DEVELOPMENT APPLICATION ASSESSMENT REPORT

Application Number:	DA2022/1363
Responsible Officer:	Adam Urbancic
Land to be developed (Address):	Lot 13 DP 6195, 3 Orana Road MONA VALE NSW 2103
Proposed Development:	Demolition works and construction of a dwelling house including swimming pool, detached garage and studio
Zoning:	R2 Low Density Residential
Development Permissible:	Yes
Existing Use Rights:	No
Consent Authority:	Northern Beaches Council
Land and Environment Court Action:	No
Owner:	Steven Paul Halpin Julie-Anne Halpin
Applicant:	Sheralee Patricia Hogan
Application Lodged:	25/08/2022
Integrated Development:	No
Designated Development:	No
State Reporting Category:	Residential - Single new detached dwelling
Notified:	08/09/2022 to 22/09/2022
Advertised:	Not Advertised
Submissions Received:	2
Clause 4.6 Variation:	Nil
Recommendation:	Approval
Estimated Cost of Works:	\$ 2,010,000.00

Figure 1: Extract from Drawing No. DA07, Rev A depicting the breach to prescribed building envelope (shaded in red) on the south-western elevation of the dwelling house.

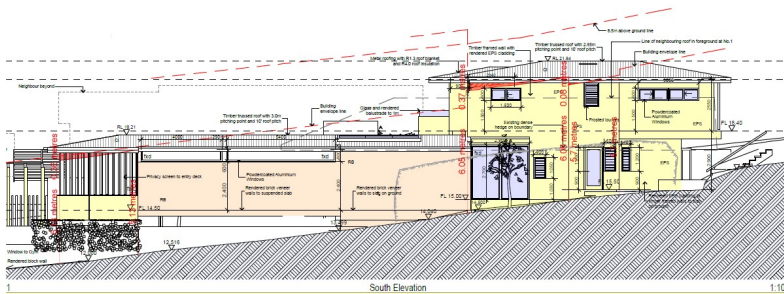
The proposed development protrudes the 3.5m prescribed building envelope on the south-western elevation of the dwelling house, as depicted on Figure 1 below.
